DESIGN ADVISORY BOARD Tuesday, September 23, 2014 Conference Room 12, City Hall, Burlington, VT AGENDA

To: The Design Advisory Board
From: Mary O'Neil, AICP, Senior Planner *mo*
RE: ZP 15-0079CA
Date: September 23, 2014

To: The Design Advisory Board
From: Mary O'Neil, AICP, Senior Planner
RE: ZP 15-0254CA; 434-436 South Winooski Avenue
Date: September 23, 2014

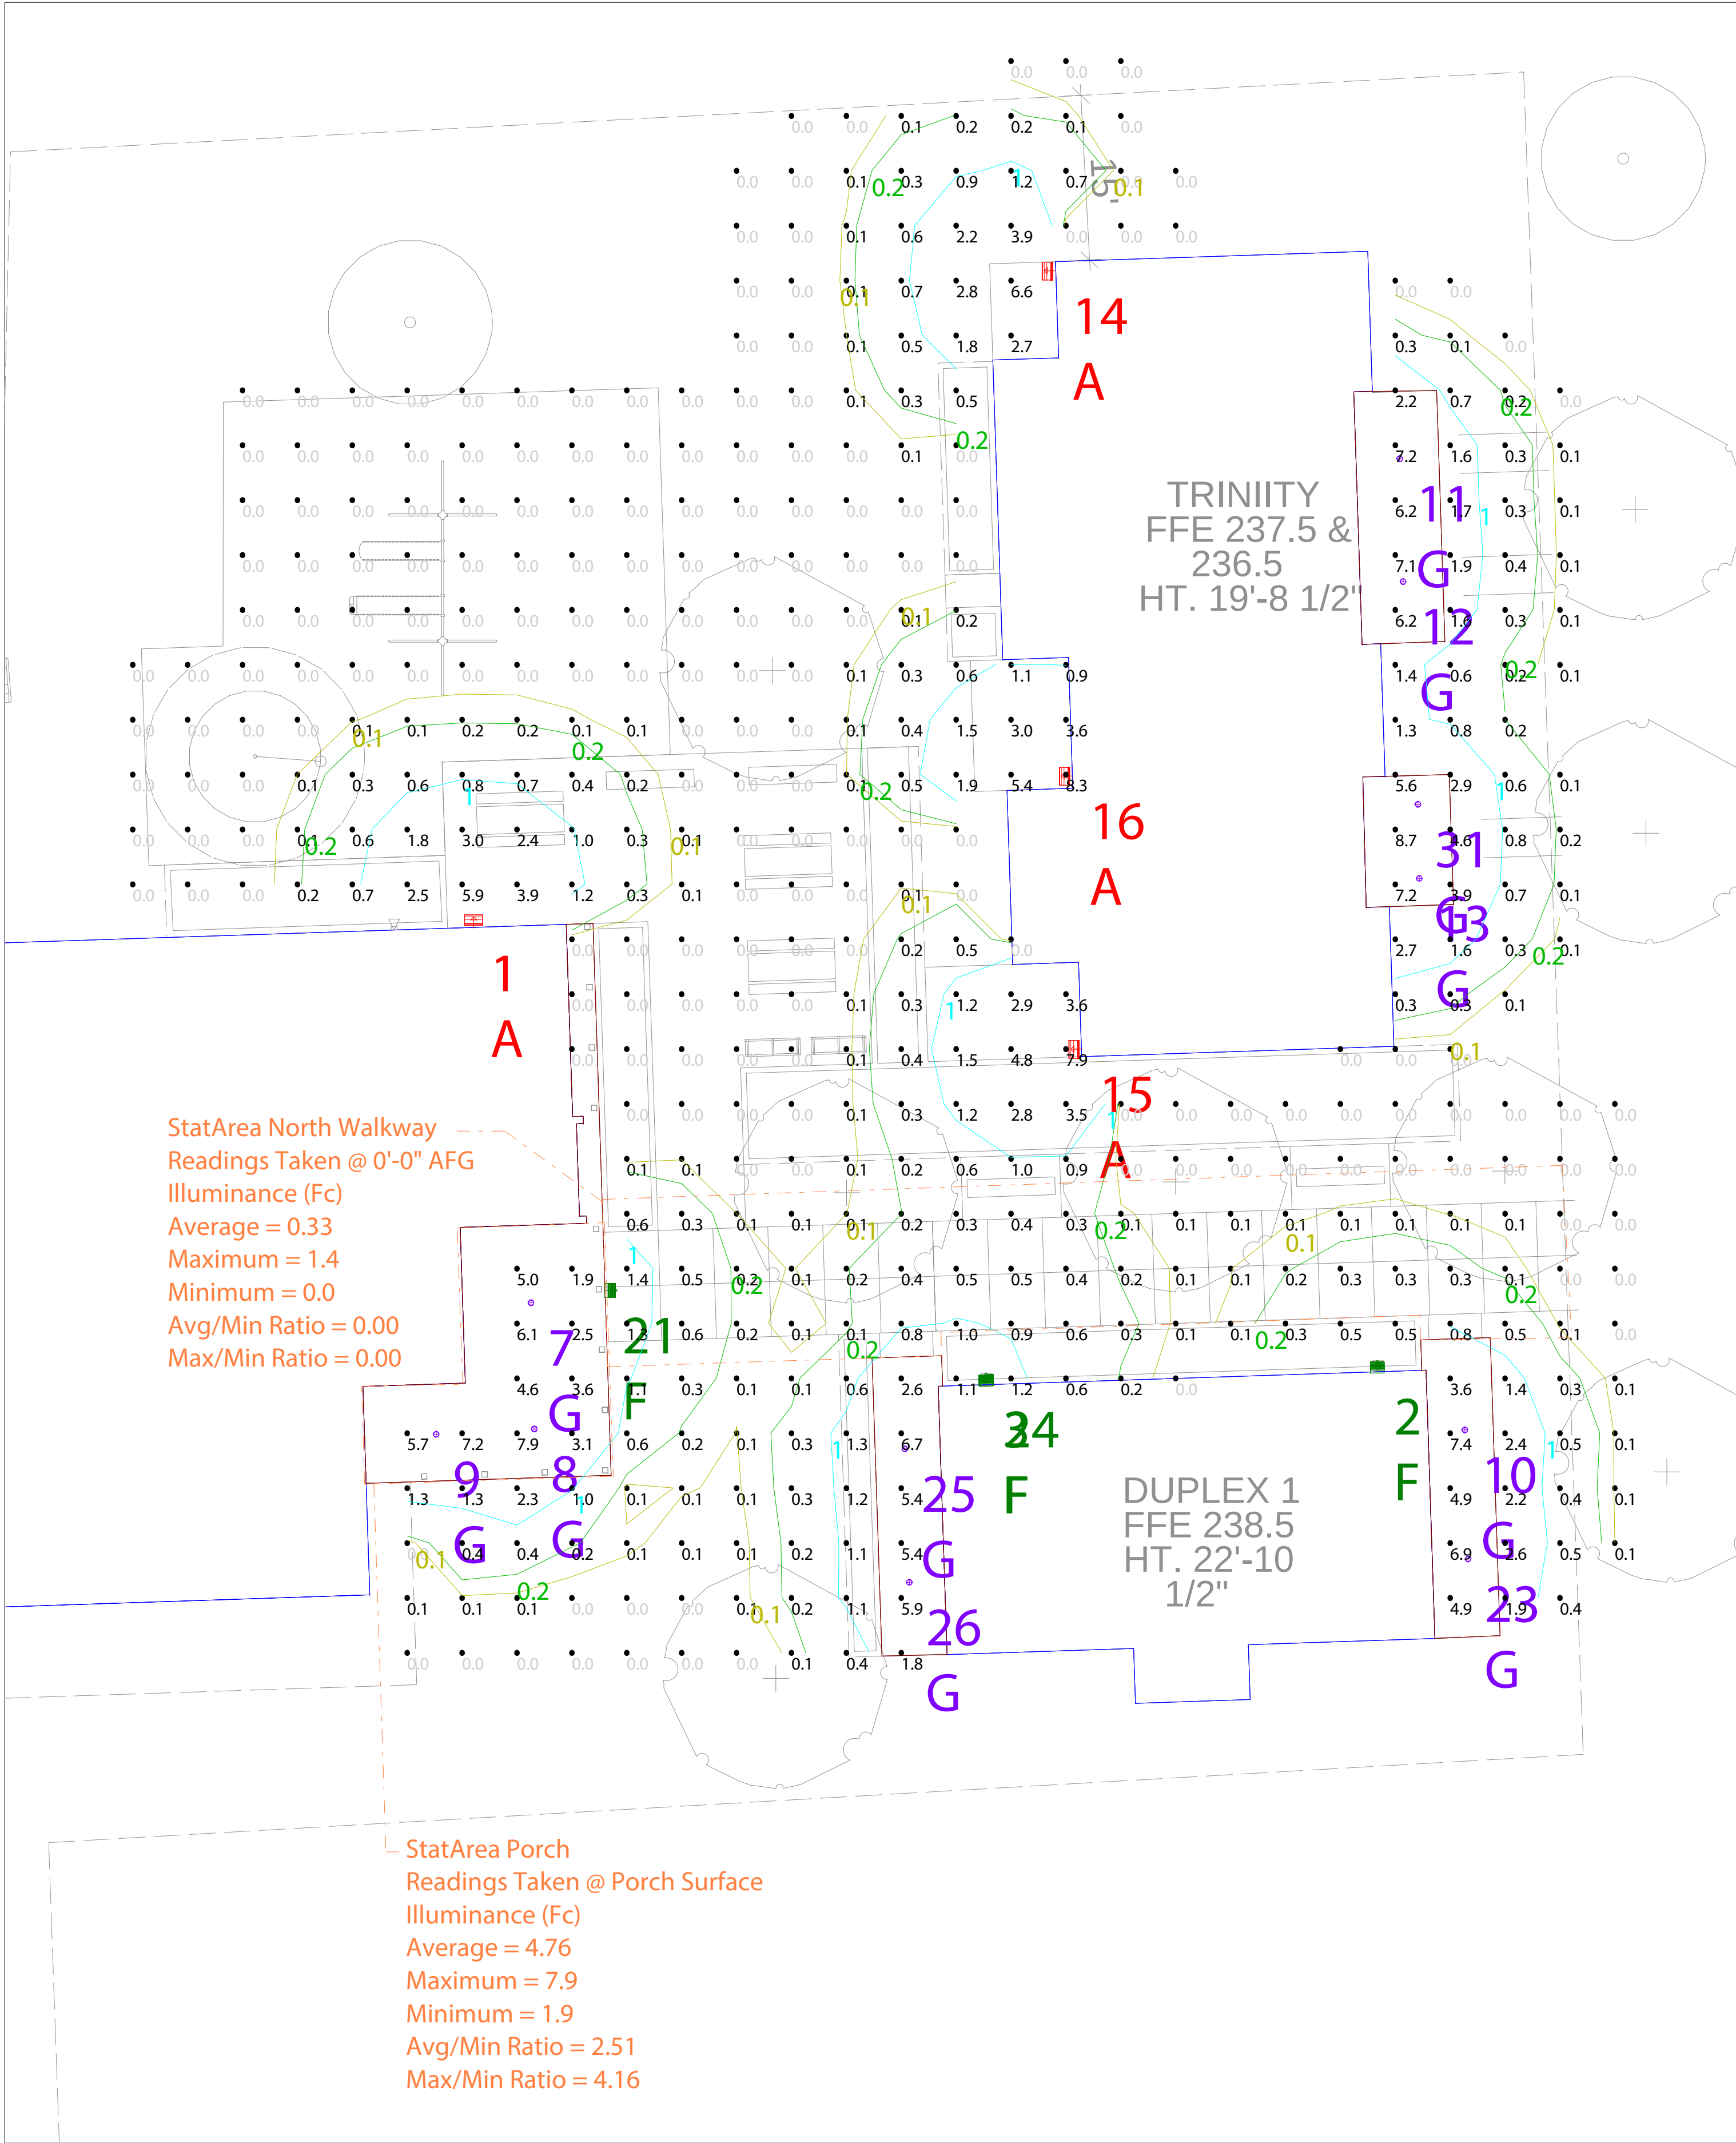
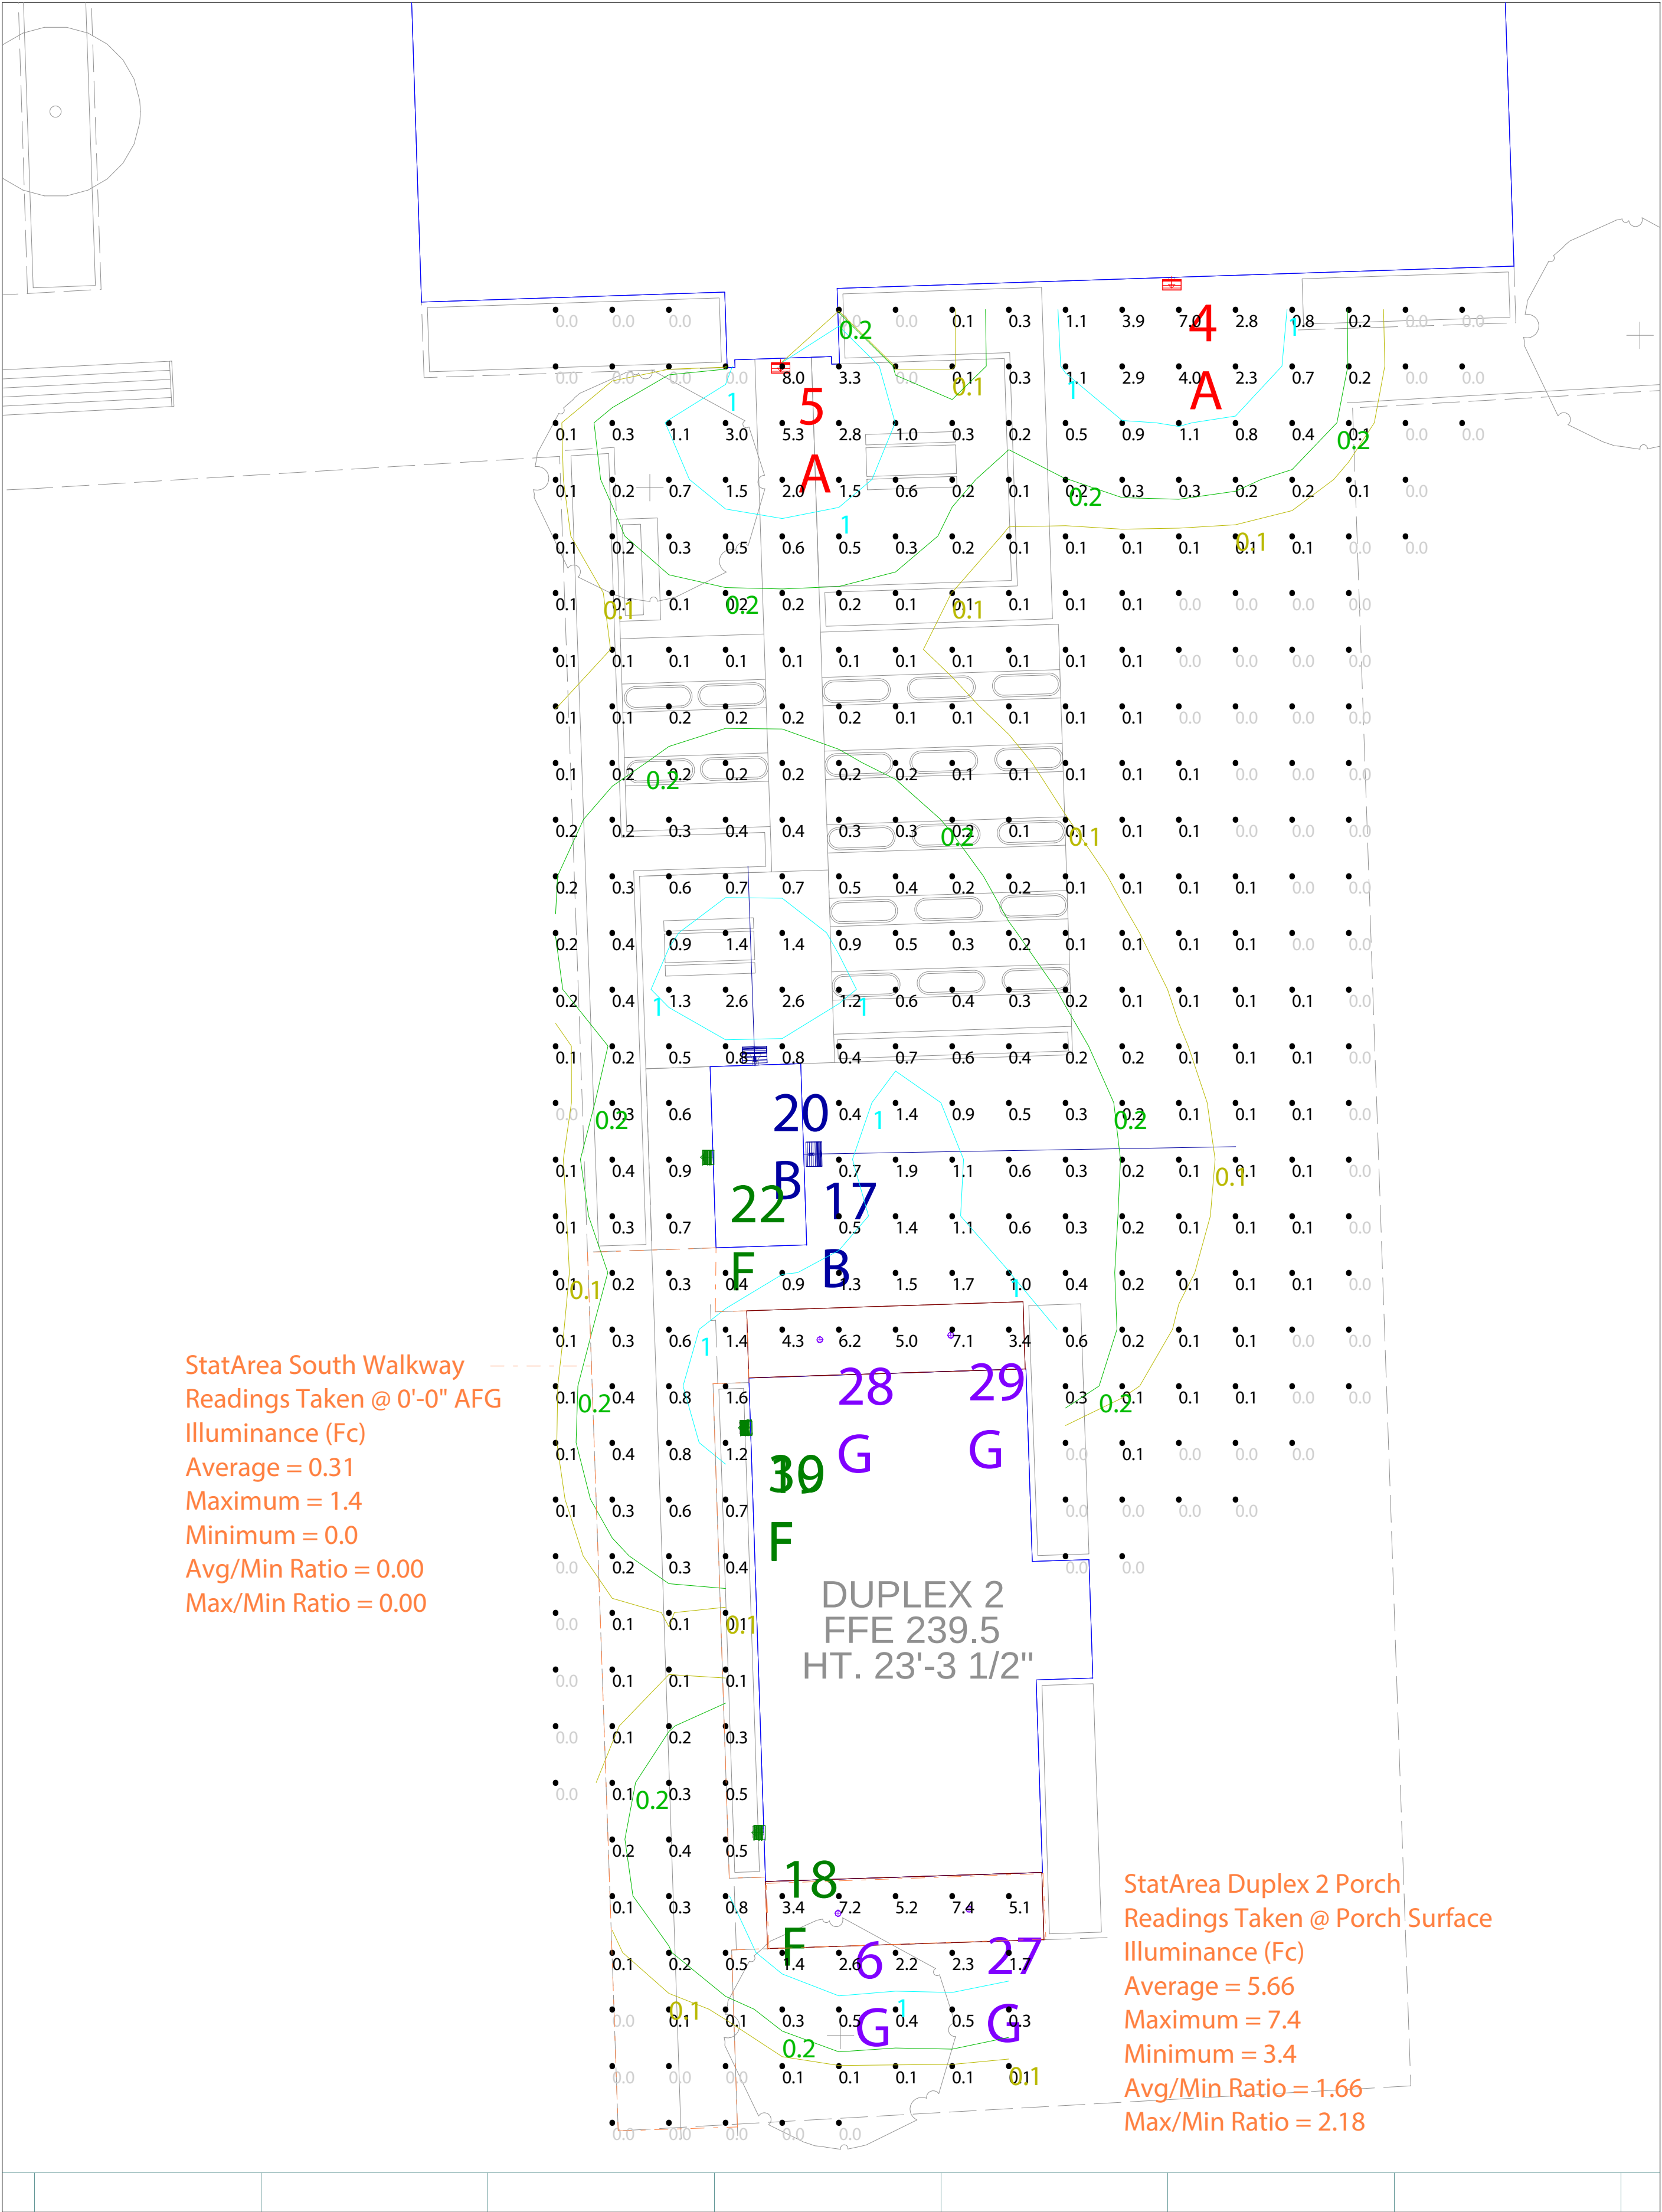
Lighting at building entrances exceeds standards of the ***Outdoor Lighting Manual for Vermont Municipalities***, Table 2, p. 10: *Building Entry – active use, 5 footcandles average maintained.* Measurements on the lighting plan illustrate entryway lighting between 5.1 fc (duplex 2 on Archibald Street) to 8.7 fc (Trinityeast entrance.) All building entrances exceed the 5 footcandle limitation, and will require revision to meet these standards, or confirmation that the average maintained level meets the standard.

3. Lighting at building entrances exceeds standards of the ***Outdoor Lighting Manual for Vermont Municipalities***, Table 2, p. 10: *Building Entry – active use, 5 footcandles average maintained*. Measurements on the lighting plan illustrate entryway lighting between 5.1 fc (duplex 2 on Archibald Street) to 8.7 fc (Trinityeast entrance.) All building entrances exceed the 5 footcandle limitation, and will require revision to meet these standards, or confirmation that the average maintained level meets the standard.
